**METROPOLITAN GOVERNMENT OF NASHVILLE AND DAVIDSON COUNTY**

**STAFF RECOMMENDATION**  
**2001 Russell Street**  
**April 16, 2014**

**Application:** Demolition—outbuilding; New construction—detached accessory dwelling unit

**Description of Project:** The applicant proposes to build a Detached Accessory Dwelling Unit (DADU) at the rear of the property, behind a historic house.

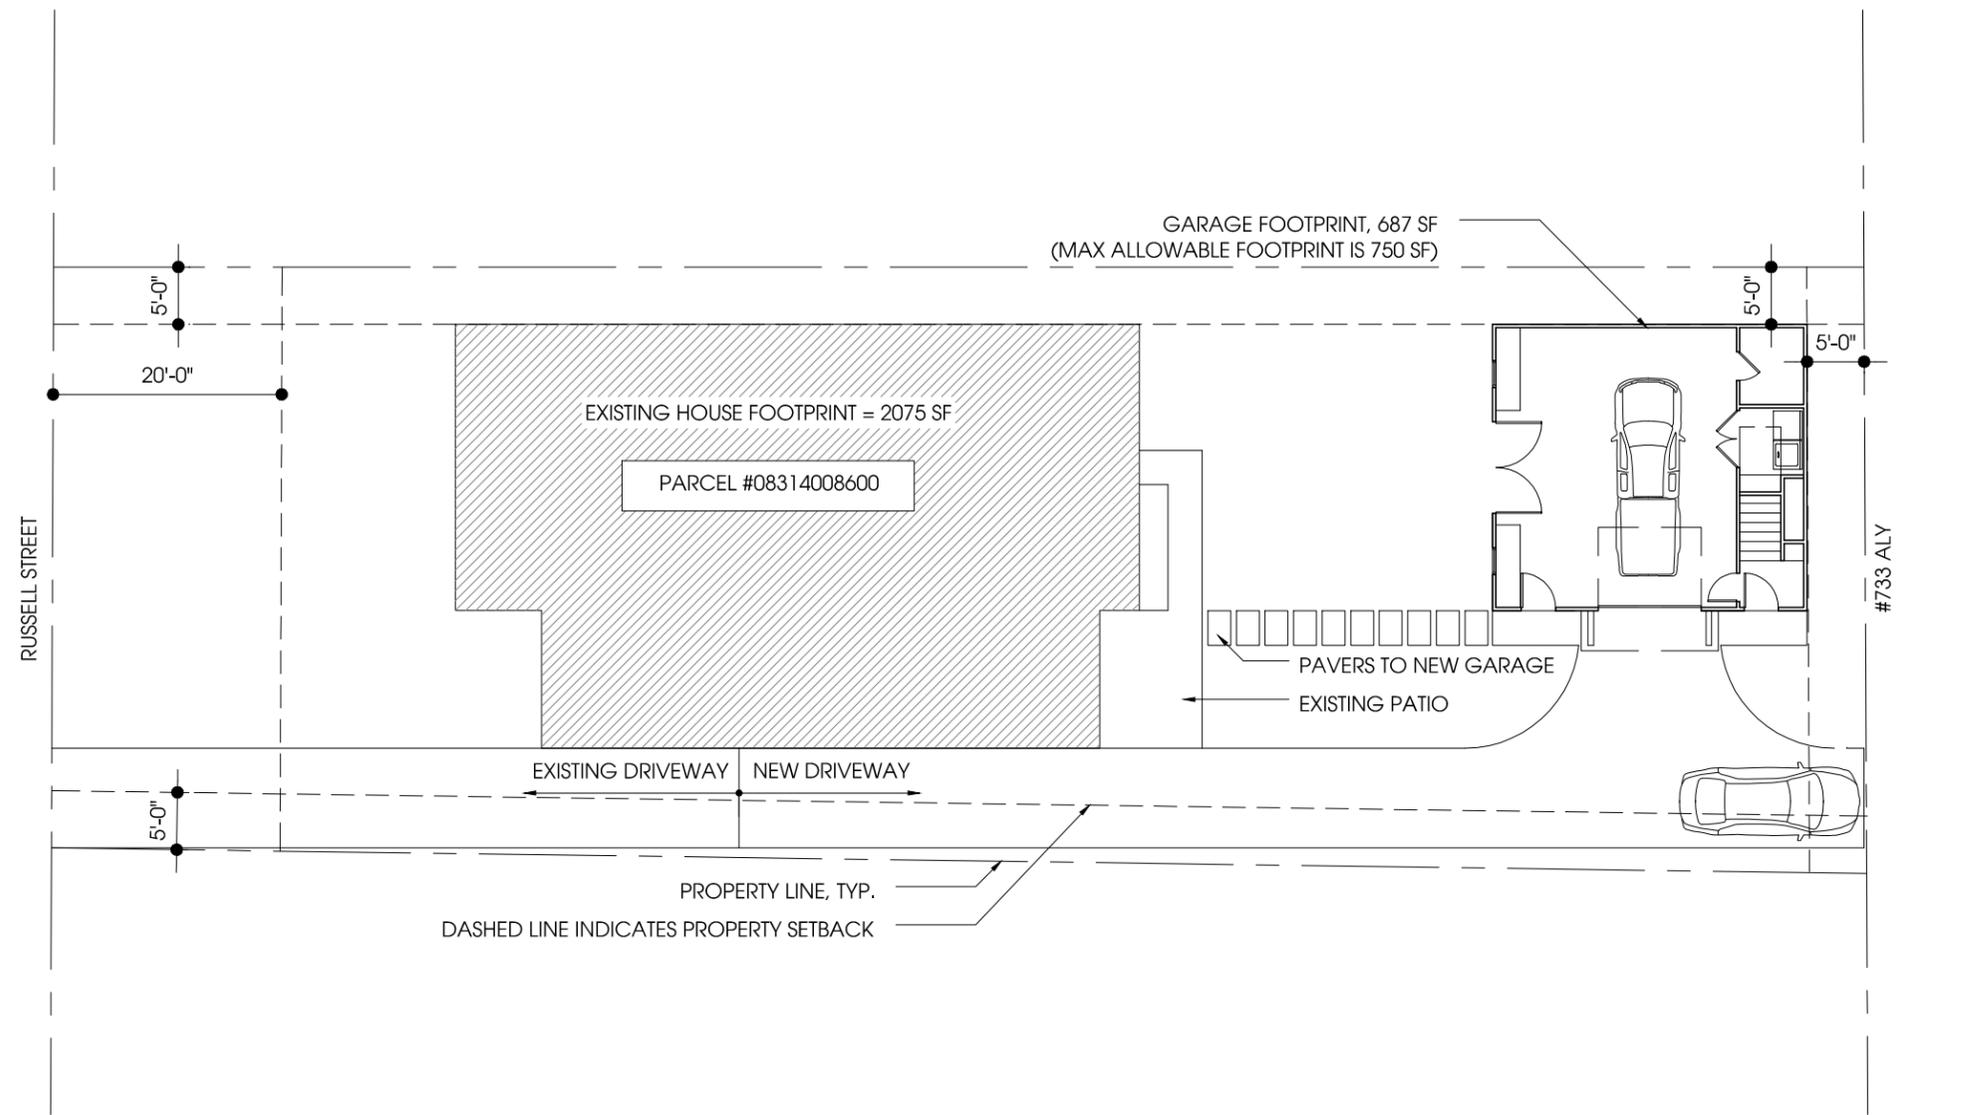
Design Standards. The outbuilding's design is compatible with the style of the historic structure. Its roof, detailing, and overall form do not contrast greatly with the primary structure. The structure's stairs are located on the interior. Its roof form includes shed dormers on the north and south elevations. The dormers sit back two feet (2') from the wall below them, and they occupy less than fifty percent (50%) of the roof. The fenestration pattern is appropriate for an outbuilding, and the structure is in a minimally-visible location at the rear of the historic structure. The proposed outbuilding therefore meets Standard 8 of the Detached Accessory Dwelling Unit regulations and II.B.1.8. of the design guidelines.

Materials: The foundation is a concrete slab. Primary cladding material will be fiber cement siding with a five inch (5") reveal. In the gable fields, fiber cement smooth panels and battens will be used. Wood brackets will be incorporated to match those on the house. The second story balcony rail will be metal. The windows will be fiberglass or aluminum clad, and staff asks to approve all window and door specifications prior to purchase and installation. The roof will be asphalt shingle, and staff asks to approve the shingle color. With the aforementioned staff approvals, staff finds that the materials meet section II.B.8. of the design guidelines.

Roof form: The outbuilding will have a side-gabled roof with clipped gables, matching the roof form of the historic house. The gable will have a pitch of 8/12. The shed dormers will have a pitch of 3/12. Staff finds that the outbuilding's roof form meets section II.B.8. of the design guidelines.

**A2.0**

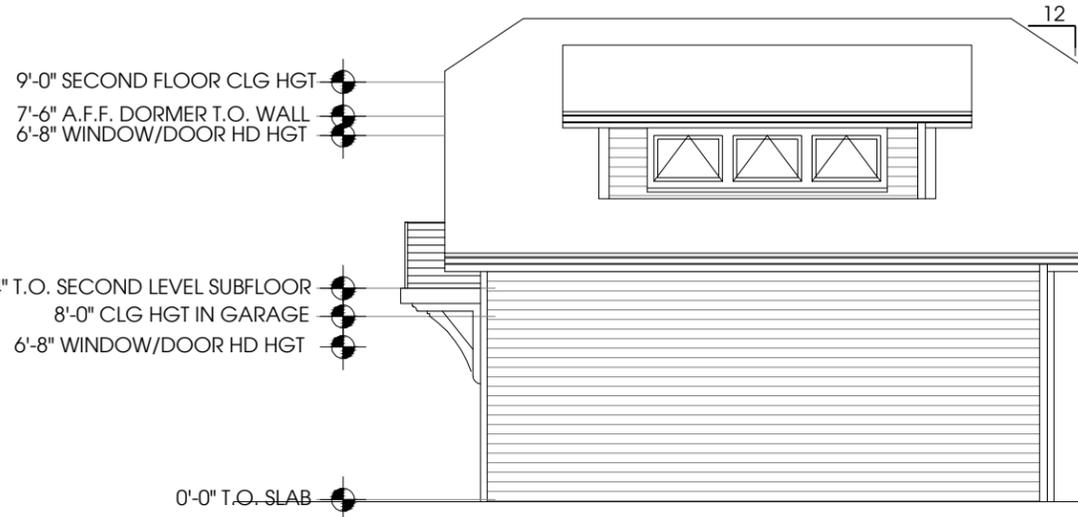
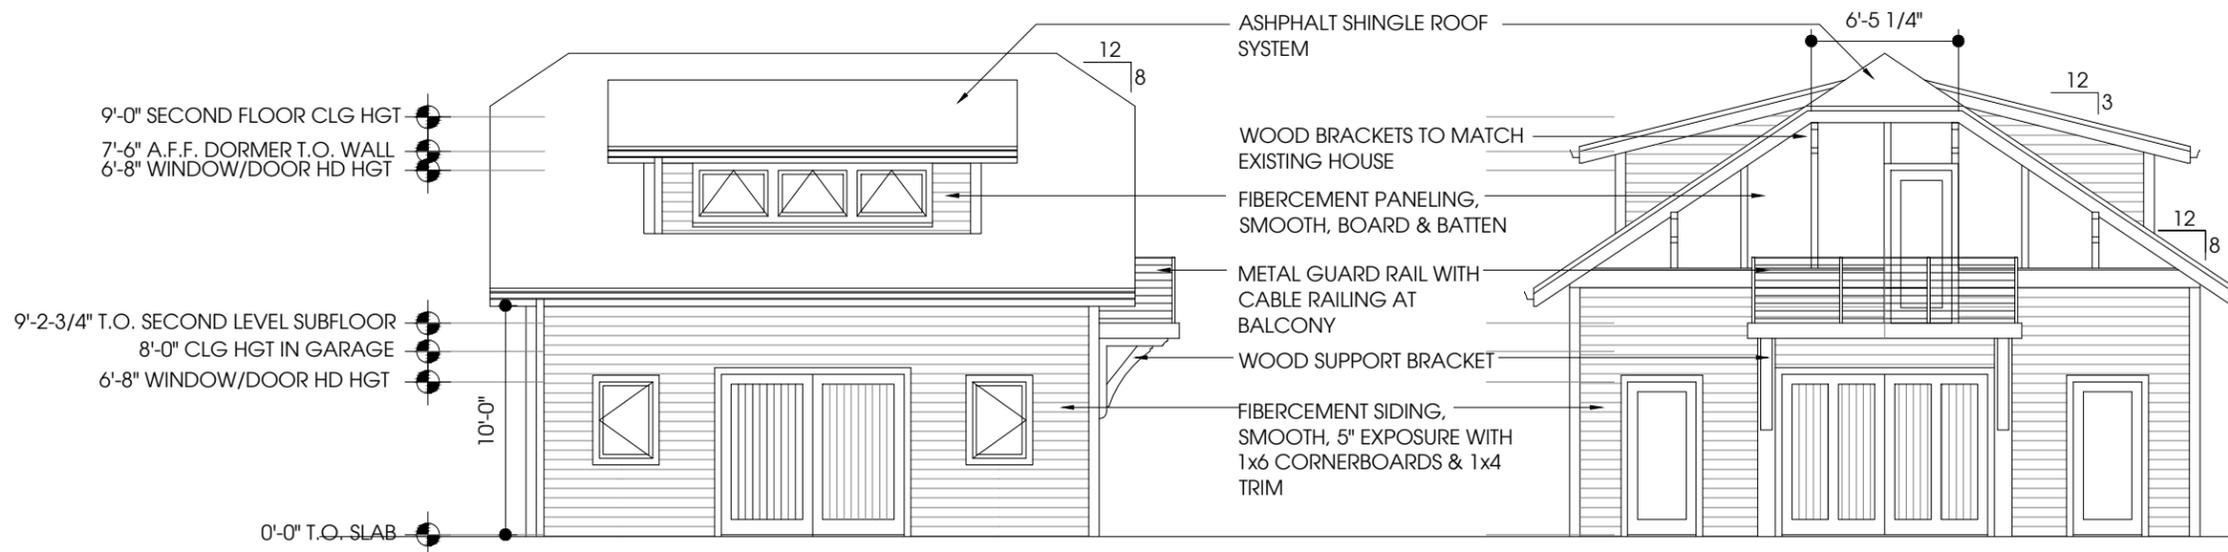
Bulk and Massing. The accessory structure is one-and-a-half stories tall. Its footprint is approximately six hundred and ninety-four square feet (694 sq. ft), less than the maximum footprint of seven hundred square feet (700 sq. ft.) for one-story structures. The ridge height is approximately twenty-one feet (21') from grade and the eave height is

ten feet (10'). These are both subordinate to the historic house, which has an eave height of eleven feet (11') and a ridge height of twenty-four feet (24'). The structure meets Standard 7 of the Detached Accessory Dwelling Unit regulations.
